Arundel Street – Manchester

DESIGN & ACCESS STATEMENT ADDENDUM | APRIL 2022

This Design and Access Statement Addendum by SimpsonHaugh has been prepared in support of proposed amendments to the approved planning application (ref. 123261/FO/2019) for the following:

Level 0 - Proposed Amendments

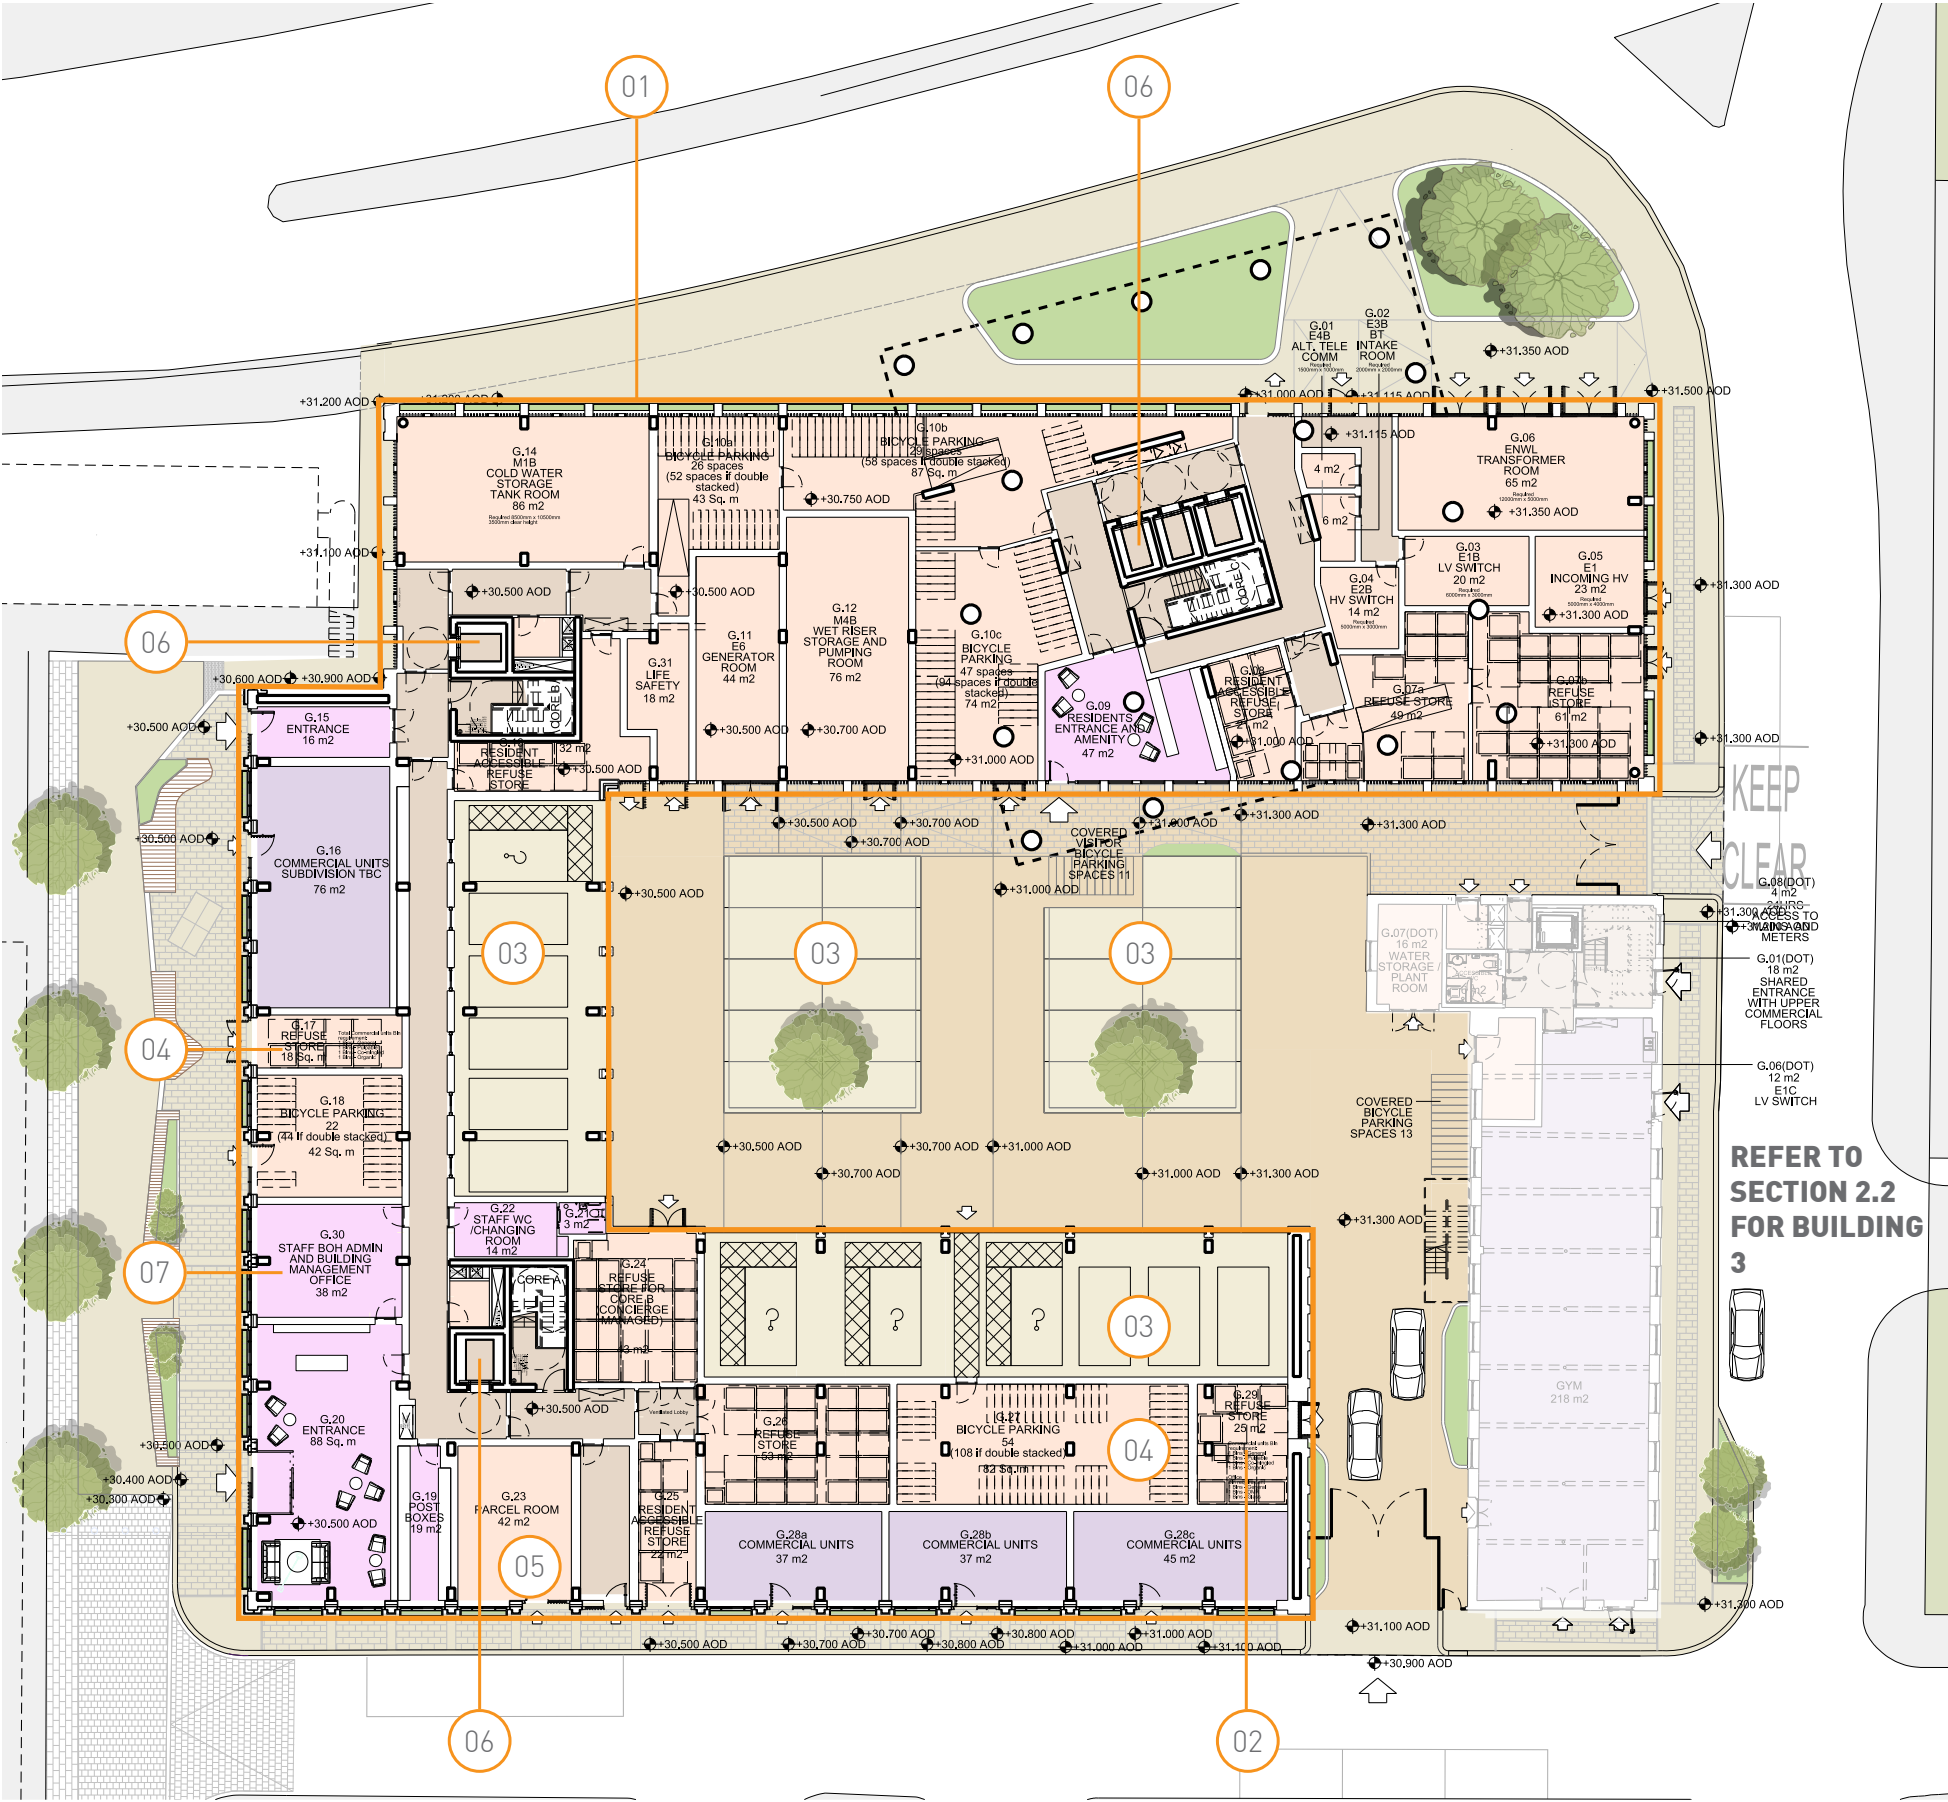
The amendments to the ground floor comprising adjustments to the arrangement to suit revised core configurations and the introduction of additional support spaces to the residential entrances such as building management and staff changing.

The arrangement of Building 1 remains largely unchanged from the approved scheme, with amendments to plant rooms and the core. Access to the principal entrance to the residential core remains from the central courtyard and the frontage toward the east and the Mancunian Way is composed of plant rooms and cycle storage.

Within Building 2, the extent of commercial floorspace fronting Arundel Street has been reduced to accommodate reconfigured refuse and cycle storage but retains the extent of active frontage as the consented scheme. Facing the courtyard, car parking is retained under the curtilage of the building arrangement of accessible and standard parking spaces.

Fronting Worsley St, the arrangement is similar to the consented scheme with the exception of the addition of a building management office.

Across the ground floor, the provision of both residential cycle storage and car parking remains as the approved scheme, comprising of 355No cycle spaces and 31No car parking. In addition, it is proposed that 11No external spaces are provided adjacent to the Building 2 entrance fronting the courtyard for residential visitors.

To the rear of Building 3, 13No cycle spaces have been provided within a secure and covered enclosure which are allocated to the commercial and leisure spaces within the development (9No for Building 3; 4No for Building 1).

Amendment to the landscaping have been made to suit adjustments to entrances, car and cycle parking, and levels but the generally arrangement of soft and hard landscaping and materiality remain as the approved scheme.

- 01 AMENDMENT TO INTERNAL LAYOUT TO SUIT COMBINED PLANT/SUPPORT REQUIREMENTS FOR CONSOLIDATED RESIDENTIAL ACCOMMODATION
- 02 REFUSE STORE AMENDED TO INCLUDE PROVISION FOR BUILDING 3 COMMERCIAL AND LEISURE SPACES
- 03 CAR PARKING ARRANGEMENT AMENDED AND RETAINS PROVISION MADE IN APPROVED SCHEME
- 04 ONSITE CYCLE STORAGE CONSOLIDATED IN BUILDINGS 1 & 2 AND RETAINS PROVISION MADE IN APPROVED SCHEME
- 05 FURNITURE STORE IS SUBSTITUTED FOR PARCEL STORE TO SUIT REVISED FUNCTIONAL BRIEF
- 06 CORE ARRANGEMENT AMENDED TO SUIT ADDITIONAL AMENITY SPACES AND CURRENT BUILDING REGS
- 07 BUILDING MANAGEMENT OFFICE/STAFF CHANGING ADDED TO SUIT REVISED FUNCTIONAL BRIEF

Levels 1-7 - Proposed Amendments

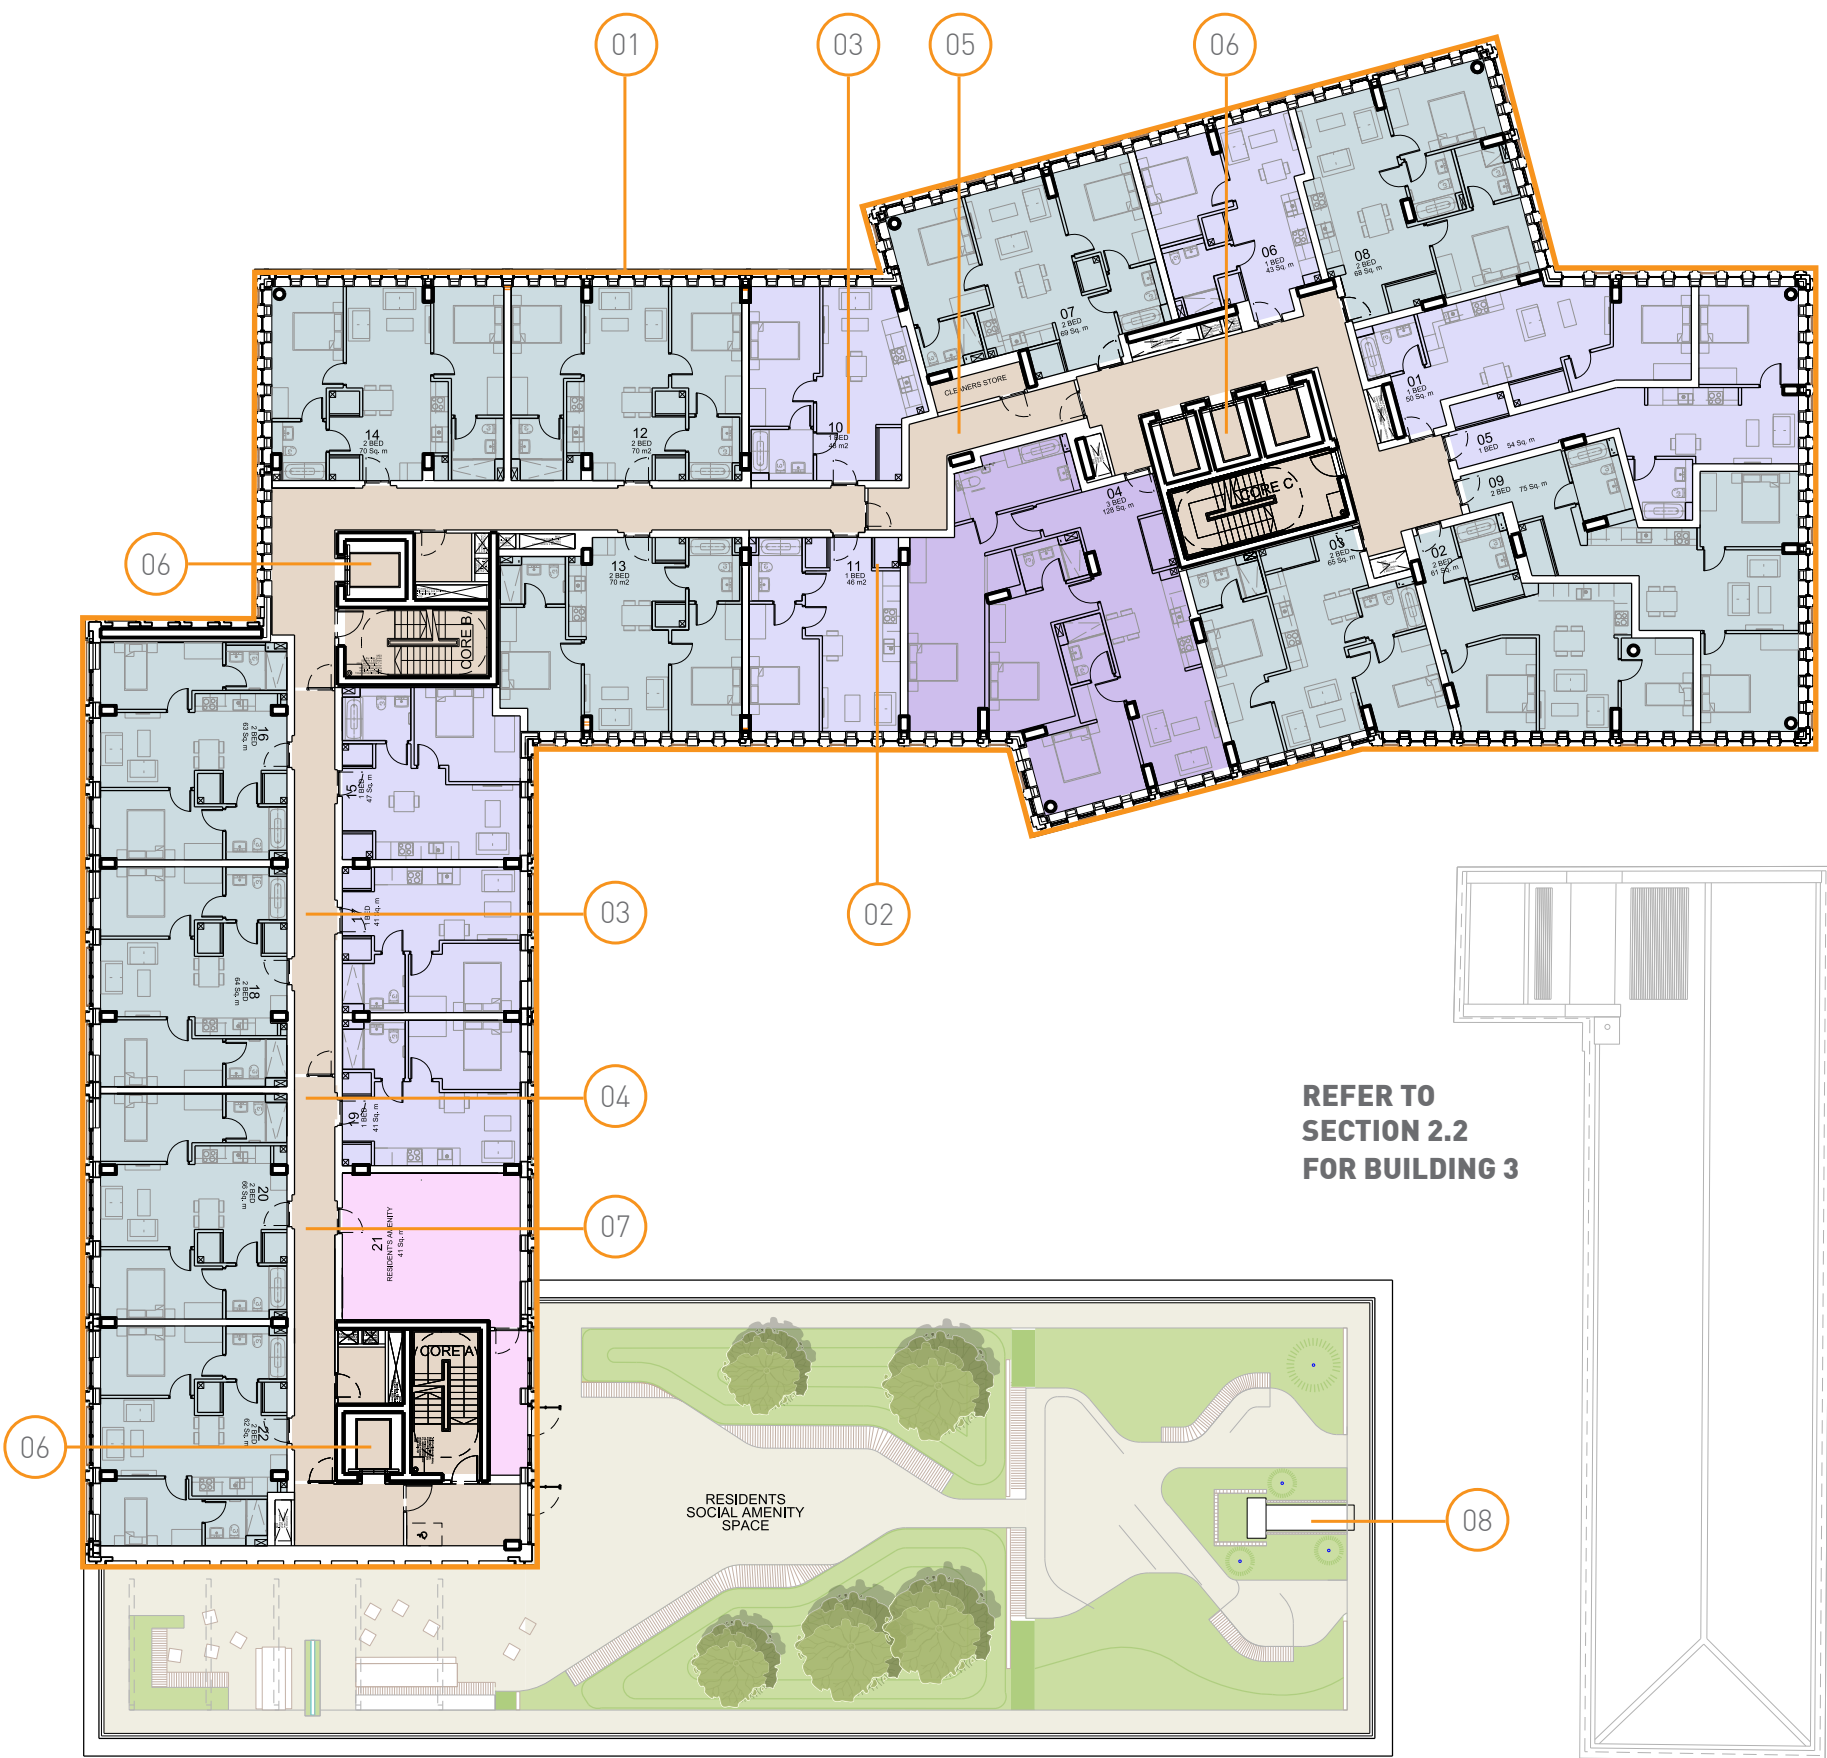
The arrangement of the residential accommodation in both buildings have been amended to suit a redistribution of the total unit numbers of the approved scheme. This amendment has enabled the decanting of the consented residential accommodation from Building 3 and the provision of additional communal amenity space on a number of levels.

On these typical lower levels, the number of apartments has been amended from 29No to 30No units, with a combination of one, two and three bedroom units with either single or dual aspect. The provision for through apartments has been omitted.

The communal corridors of each level have been amended to link each of the cores.

The layout of each apartment has been amended to incorporate the service cupboards, previously accessed from the communal corridors

- 01 APARTMENT LAYOUTS AMENDED TO ACCOMMODATE UNITS DECANTED FROM BUILDING 3 AND FOR THE PROVISION OF NEW RESIDENTIAL AMENITY SPACES ON LEVELS 08, 09, 11 & 22
- 02 SERVICE CUPBOARDS INTEGRATED INTO ALL APARTMENT - APPLIES TO ALL FLOORS
- 03 THROUGH APARTMENTS OMITTED - APPLIES TO LEVEL 01-11
- 04 LINK CORRIDOR BETWEEN CORES A & B - APPLIES TO LEVELS 01-08
- 05 LINK CORRIDOR BETWEEN CORES B & C - APPLIES TO LEVEL 01-11
- 06 CORE ARRANGEMENT AMENDED TO SUIT NEW RESIDENTIAL AMENITY SPACES AND CURRENT BUILDING REGULATIONS

Level 8 - Proposed Amendments

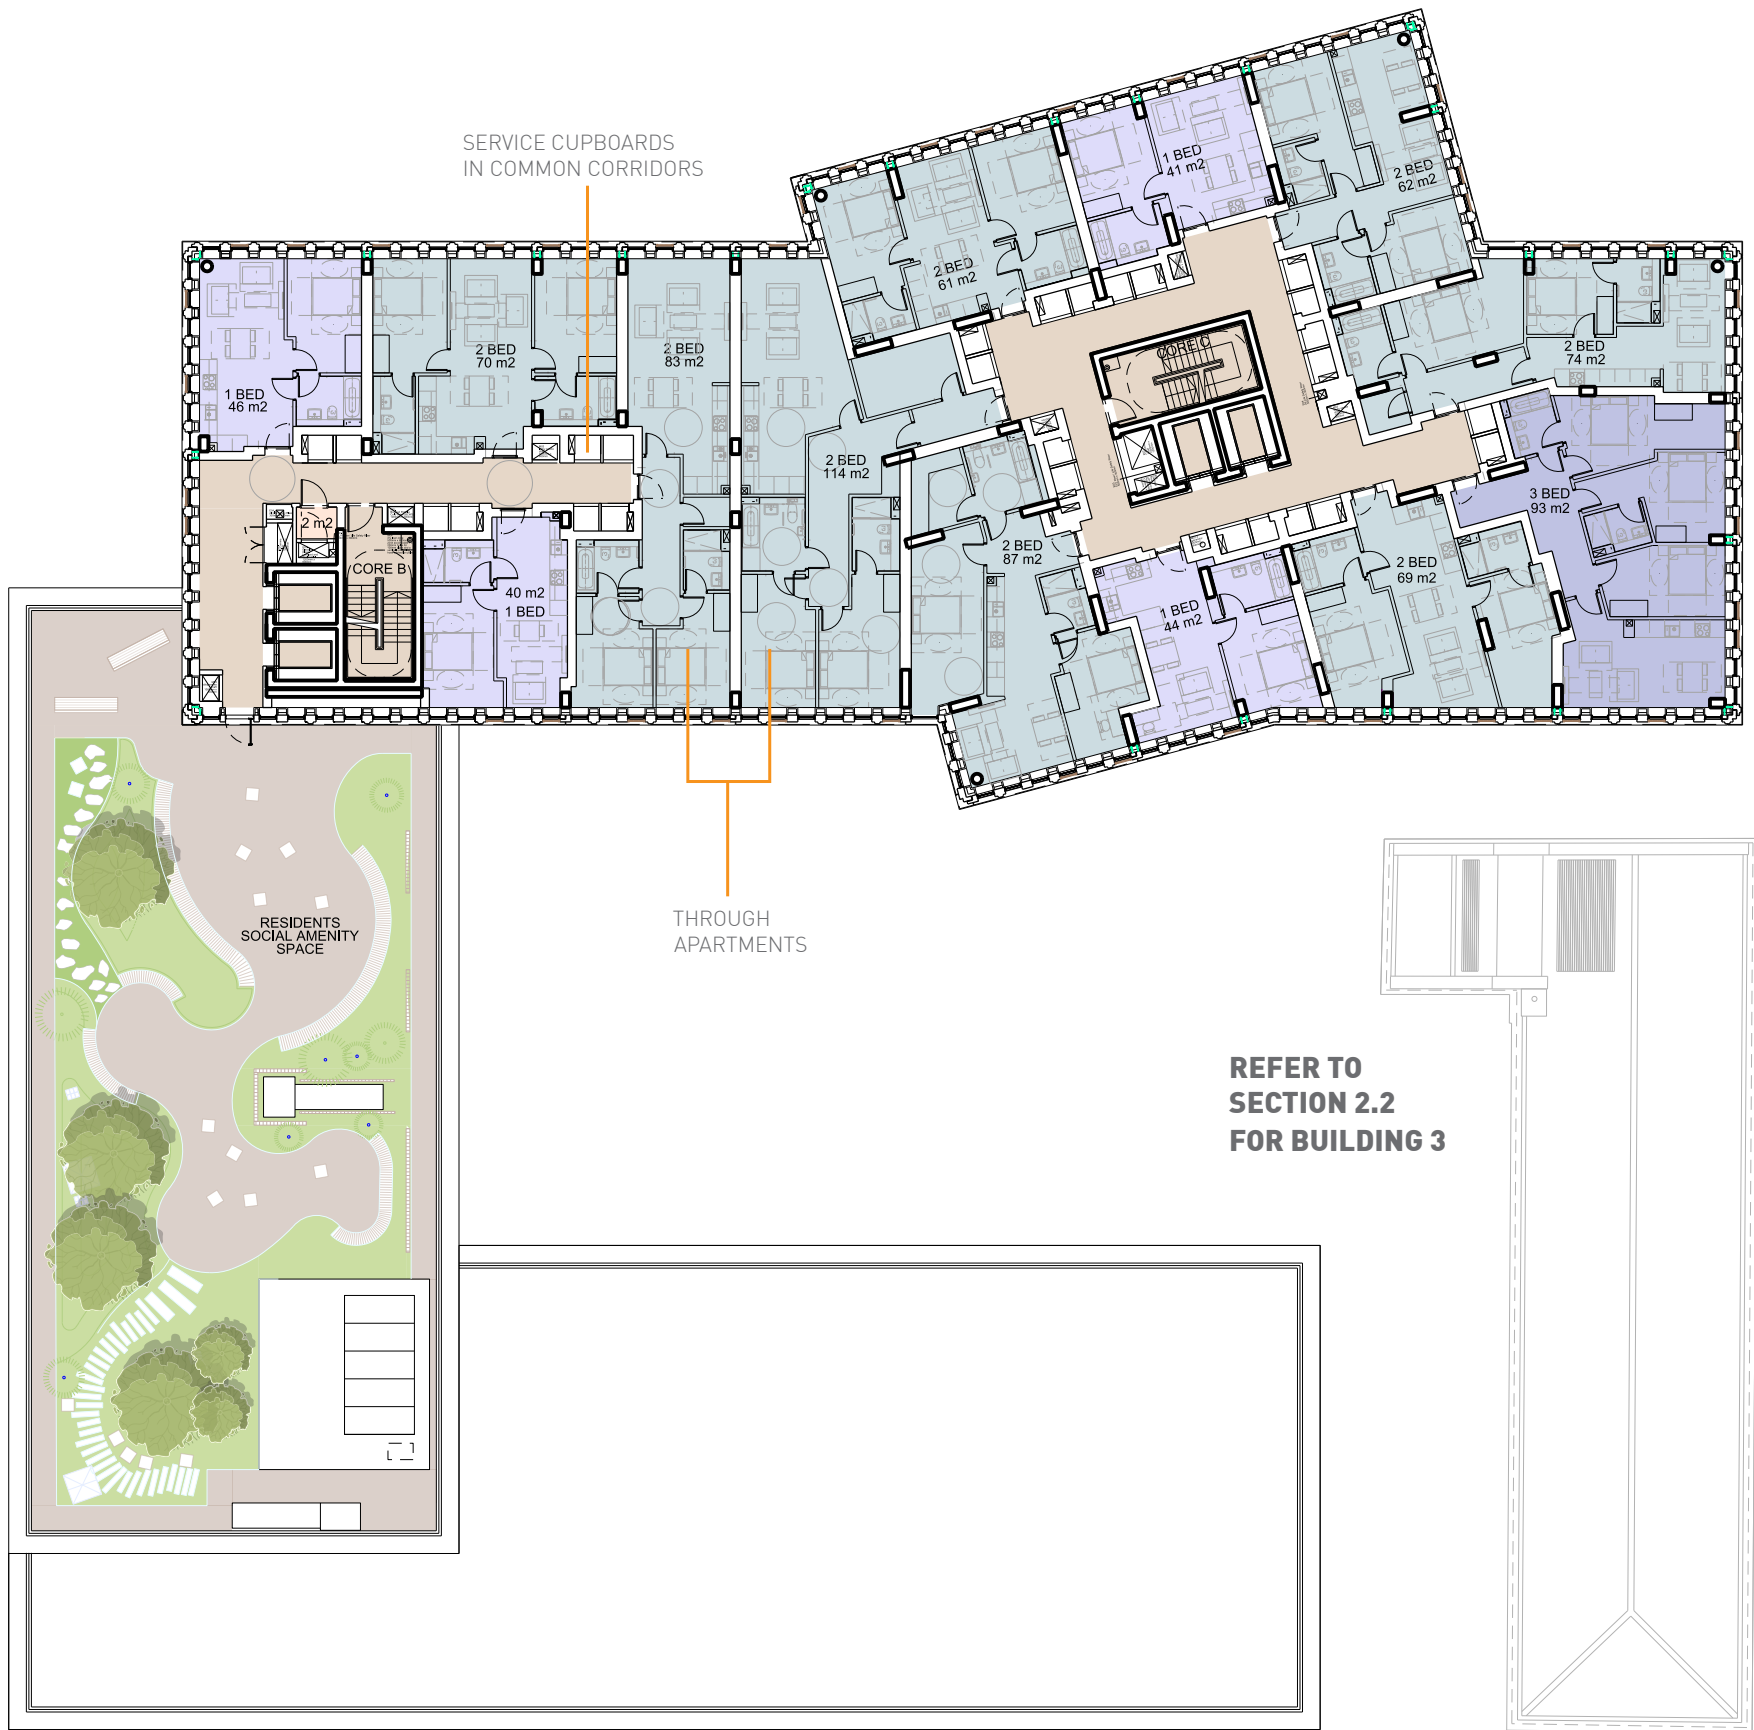
The arrangement of apartment and common circulation is similar to the lower levels.

At this level, the number of apartments remains as the approved scheme, with a combination of one, two and three bedroom units with either single or dual aspect. The provision of through apartments has been omitted.

Access to the communal roof garden is improved through the provision of the link corridor between the cores. A new internal communal amenity space is proposed adjacent to Core A, with direct access to the roof garden as an enhancement to the approved scheme.

Roof mounted plant has been amended to suit the amended configuration of the common areas below.

- 01 APARTMENT LAYOUTS AMENDED TO ACCOMMODATE UNITS DECANTED FROM BUILDING 3 AND FOR THE PROVISION OF NEW RESIDENTIAL AMENITY SPACES ON LEVELS 08, 09, 11 & 22
- 02 SERVICE CUPBOARDS INTEGRATED INTO ALL APARTMENT - APPLIES TO ALL FLOORS
- 03 THROUGH APARTMENTS OMITTED - APPLIES TO LEVEL 01-11
- 04 LINK CORRIDOR BETWEEN CORES A & B - APPLIES TO LEVELS 01-08
- 05 LINK CORRIDOR BETWEEN CORES B & C - APPLIES TO LEVEL 01-11
- 06 CORE ARRANGEMENT AMENDED TO SUIT NEW RESIDENTIAL AMENITY SPACES AND CURRENT BUILDING REGULATIONS
- 07 NEW RESIDENTIAL AMENITY SPACE ADDED
- 08 AMENDMENT OF ROOF MOUNTED PLANT TO SUIT ADJUSTMENTS TO COMMON AREAS BELOW
